NINE MILE POINT NUCLEAR STATION, UNIT NO. 1

AMENDMENT TO FACILITY OPERATING LICENSE

Amendment No. 41
License No. DPR-63

SUPPORTING AMENDMENT NO. 41 TO FACILITY OPERATING LICENSE NO. DPR-63

Figure 3.1.7d Maximum Allowable Average Planner LHGR Applicable to P8DNB277 and Future Reload Fuel as described in Reference 8.

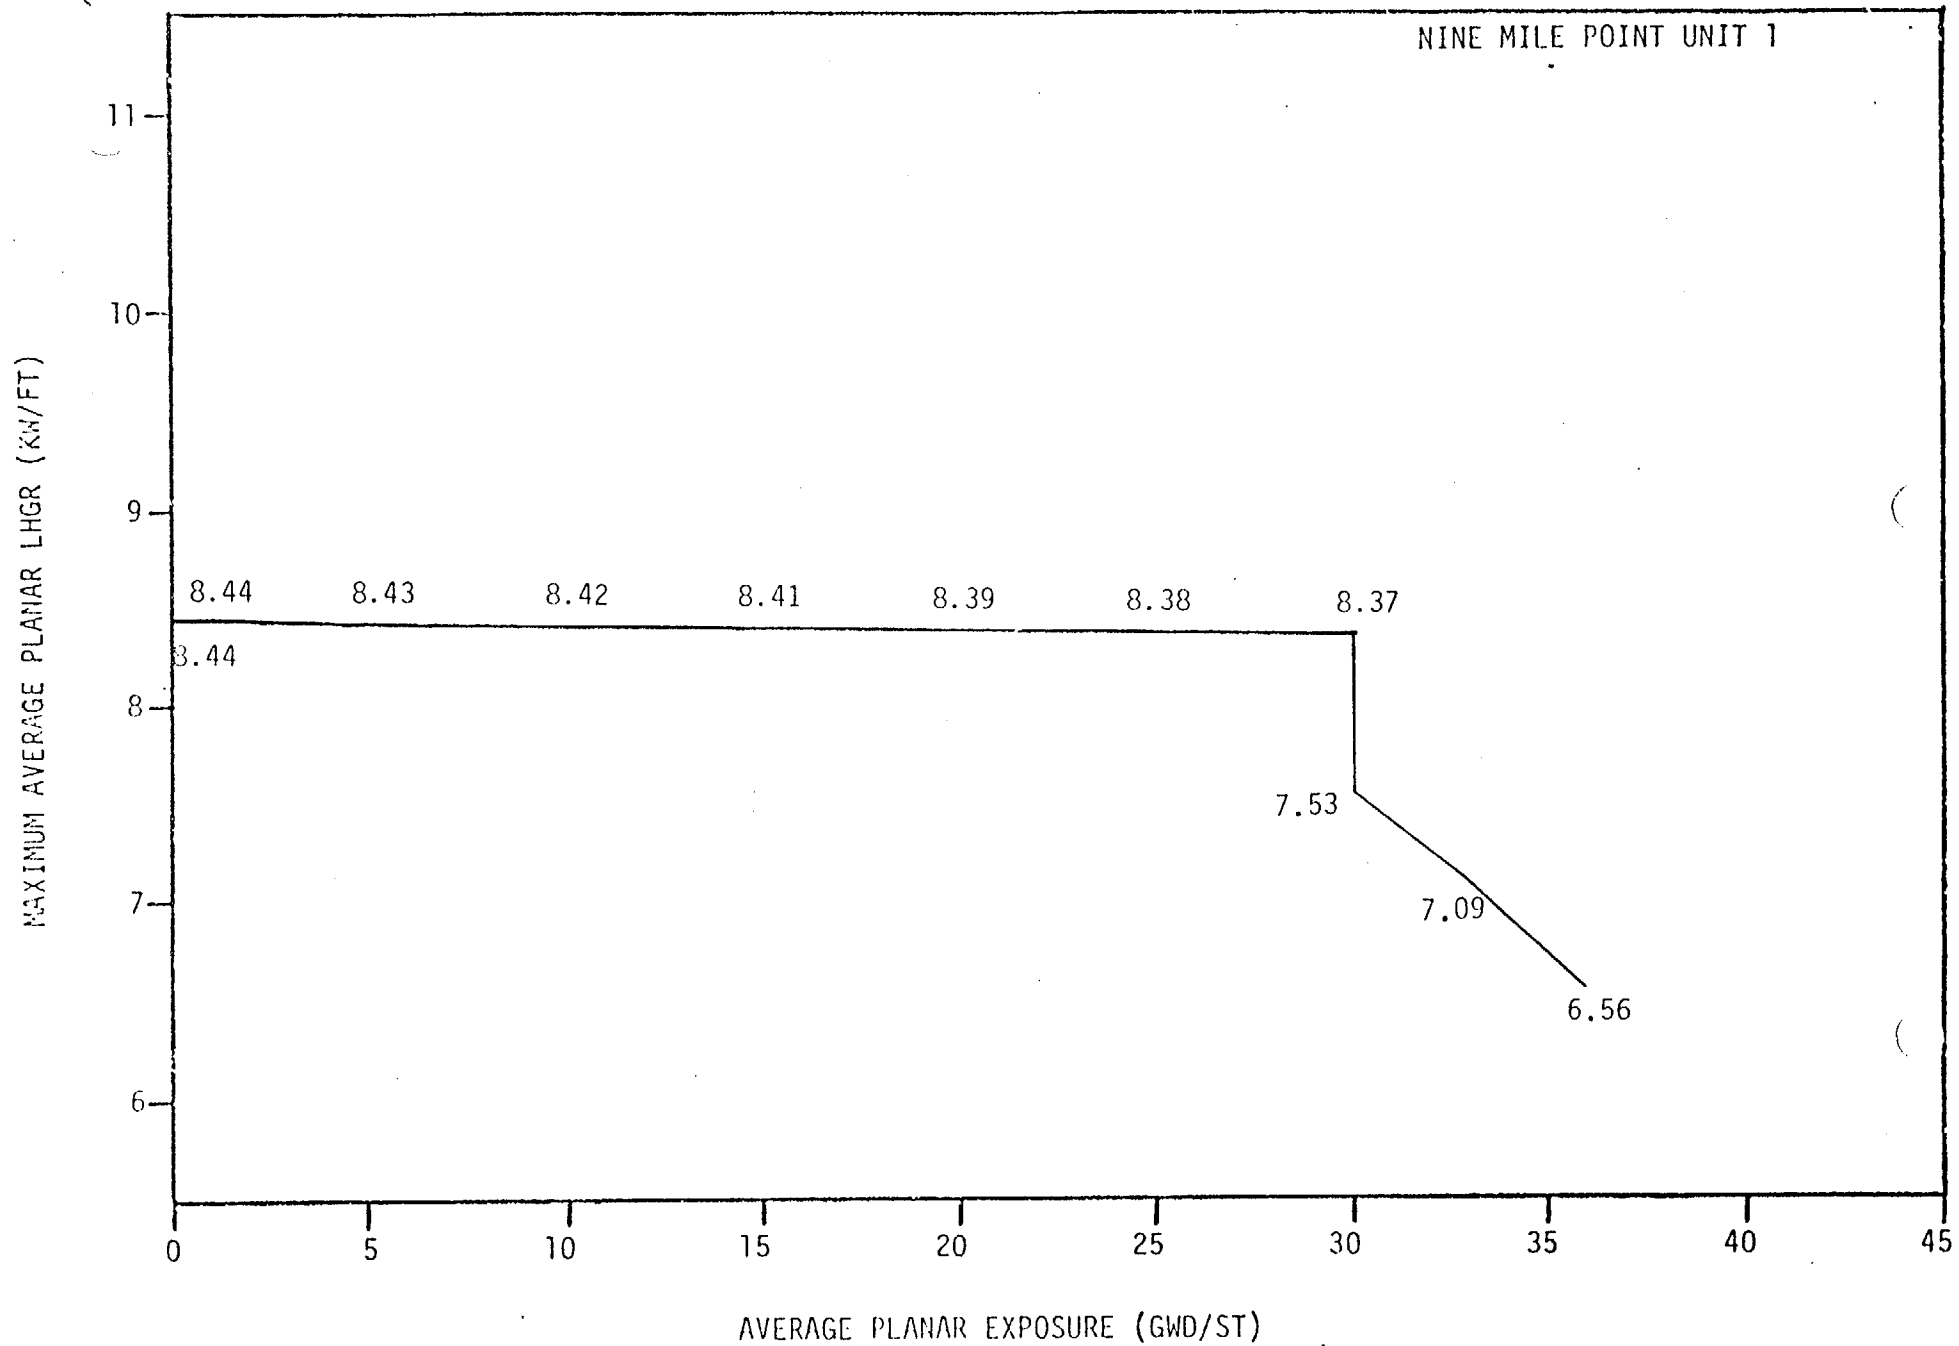
The proposed new MAPLHGR limits are calculated out to higher exposures (from 30,000 MWD/STU to 40,000 MWD/STU) by the previously approved methods initially used for the fuel with exposures up to 30,000 MWD/STU. The changes in the four figures (Figures 3.17 a, b, c, and d) are the result of extending the MAPLHGR limits to 36,000 MWD/STU for 8DB250 fuel, 8DB274L and 9DB274H fuel, 8DNB277 fuel and P8NDB277 fuel, respectively.

Although the methodology used is generally applicable for an average planar exposure up to 36,000 Mwd/t, the staff believes the effects of enhanced fission gas release in high burnup fuel (above 30,000 Mwd/t) are not adequately accounted for in your submittals. To compensate for this deficiency, the staff has estimated the amount of MAPLHGR limits in Figures 3.1.7a to 3.1.7d of the proposed Technical Specifications should be reduced to assure the peak cladding temperature and local oxidation are below the limits allowed by 10 CFR 50.46. The reduction imposed is based on the results of comparative calculations of fuel volume average temperature performed by General Electric using GEGAP III with and without an NRC correction for enhanced fission gas release and the relationship between peak cladding temperature and MAPLHGR increased presented in NEDE-23786-1-P. In estimating the MAPLHGR reduction, the staff conservatively assumed the change in volume average temperature can be translated directly into a peak cladding temperature change. Table 1 gives the percent reduction in MAPLHGR as a function exposure above 30,000 Mwd/t for the types 8DB250, 8DN274L, H, 8DNB277 and P8DNB277 fuel in your submittals. We have limited the extension of the MAPLHGR to 36,000 Mwd/t to account for the uncertainties in enhanced fission gas release above this exposure.

These MAPLHGR reductions to the licensee's proposed Technical Specifications in Figures 3.1.7a to 3.1.7d assures that the cladding temperature and local cladding oxidation would remain below the 2200°F (peak cladding temperature) and 17 percent (local cladding oxidation) limit allowed by 10 CFR 50.46 when the effects of enhanced fission gas release above 30,000 Mwd/t are conservatively accounted for.

TABLE 1 - REDUCTION IN MAPLHGR AS A FUNCTION OF EXPOSURE

Exposure Mwd/t	30,000	32,000	34,000	36,000
Reduction MAPLHGR, %	10.0	13.33	16.67	20.0
